# Vieux Carré Commission Architecture Committee Meeting

Tuesday, August 22nd, 2023

235-41 Bourbon

239 - 241 BOURBON ST. VCC REVIEW | OCT 2022

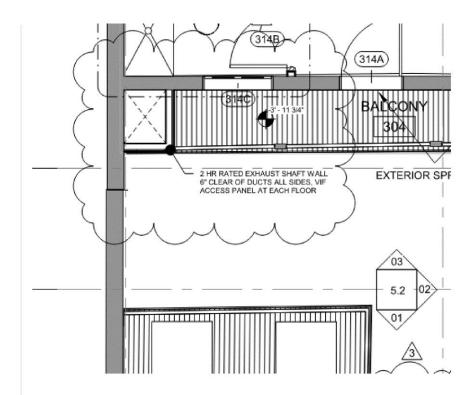
One of the doors to the bar (100D) was previously in-swinging French doors but is now shown as an out-swinging single leaf door

The door is an egress door per Fire Marshal and BBSA.

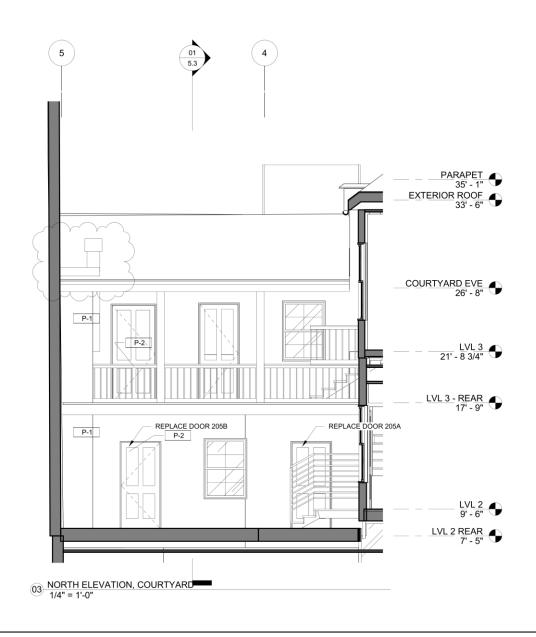
On sheet S201 (page 47), there is a detail showing a typical balcony support. The detail shows the addition of a new L shaped metal brace at each existing balcony support. It appears that the new metal brace is proposed to be welded to every outrigger of the balcony. Staff finds that this proposed work would make a major impact on the appearance of the underside of the balcony and would be highly inappropriate. Staff seeks clarity on this proposed detail and recommends that more traditional methods be used to reinforce the balcony if needed. Instead of an 'L' plate, new flat plate balcony support plates will be added to existing balcony supports, needed for 100 PSI per weight/usage.

Two tie back details are also seen on this same sheet. One detail appears to be completely on the interior of the building while the other shows an exterior 10" x 10" plate. These tie back plates are not shown on the elevation and it is unclear how many are being proposed and their exact location. If exterior tie backs are proposed, staff notes that the Committee has established a preference for circular, rather than square tie back plates." There will be 4 circular 10" plates seen on \$102/\$103.

RELATIVE OREINTATION & NAMES OF BASIC FIRE SPRINKLERS WITH REQUIRED ESCUTCHEONS

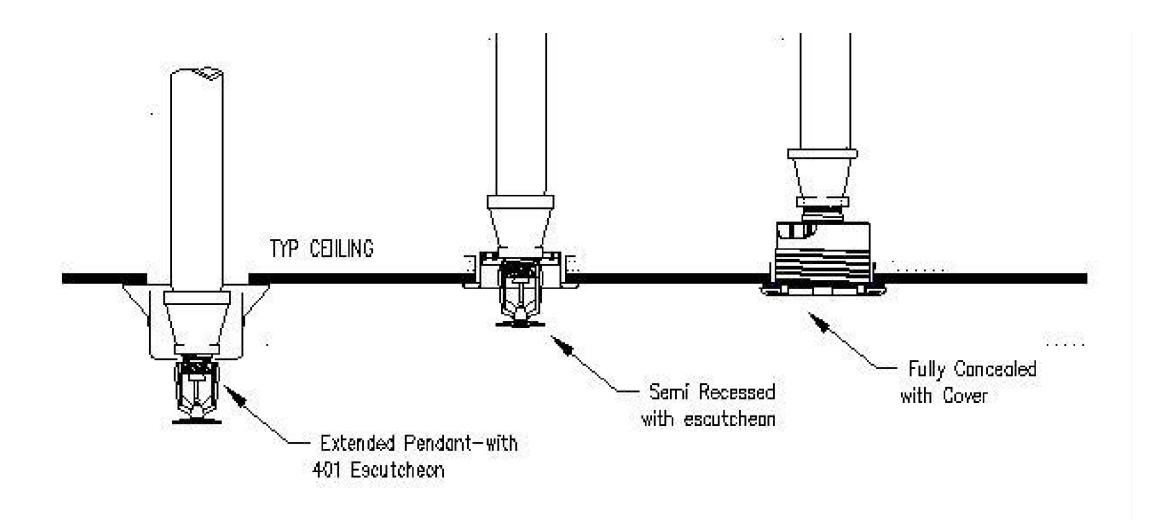
Exterior sprinklers are now shown at the second and third floor on the Bienville side of the building. Likely need some more details on these

These would be dry pipe sprinklers with a cut sheet to be given to VCC and Fire Marshal prior to installation. They will likely be a version of Viking exterior sprinkler heads.
